SERVICE LETTER SL49 35A-51650

1. Release Date: 06/10/2021
2. Service Letter No.: SL49 35A-51650
3. Subject: Safety Wires
4. Part/Assembly No.: 35A-51650
5. Float Model Affected: 3400
6. Compliance: **Mandatory** **Recommended** **Optional**
7. Approval: All information provided is in accordance with approved data.
8. Corrective Action: See below.
9. Time Required: 1 hour
10. Payments: Credit to Customer Under Warranty Customer Pays

Figure 2 Rear

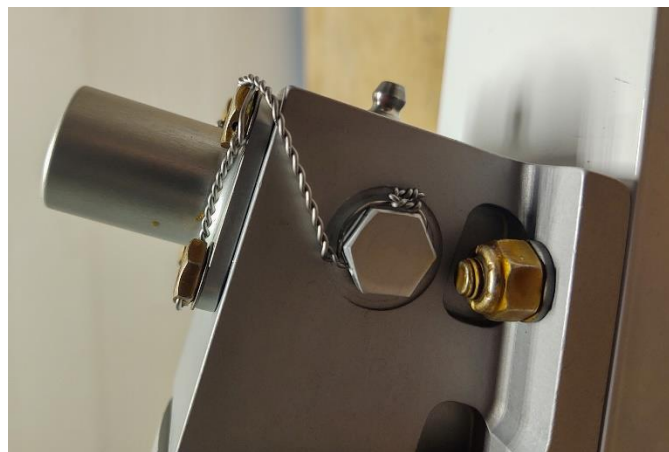
It was brought to our attention that Ø.032 safety wire was not used according to type design on the lower nose gear assembly of 3400 floats. Safety wire Ø.020 was used instead. This does not affect the safety of the floats as a double twist method was used with the Ø.020 safety wire; however, during the next inspection, if appropriate, replace with Ø.032 wire.

Safety wire of .020 inch diameter (double strand) may be used on parts having a nominal hole diameter between .045 and .062 inch with a spacing between parts of less than 2 inches. (AC43.13-1, §7-123.b.)

Because of the increased difficulty installing Ø.032 safety wire here, Aerocet has since incorporated safety cable as an acceptable alternate to safety wire. This has the advantage of optional protective jacketing, and easier installation using tooling available from aviation sources:

INSTALL SAFETY WIRE OR SAFETY CABLE WHERE NOTED.

- A. MS20995C32 SAFETY WIRE; OR
- B. AS3510-20-18K SAFETY CABLE OR PER TABLE 1; AND
- C. INSTALLATION METHODS AND TECHNIQUES IN ACCORDANCE WITH AC43.13-1. CHAP. 7, SEC. 7 (SAFETY WIRE ONLY) OR AS567.
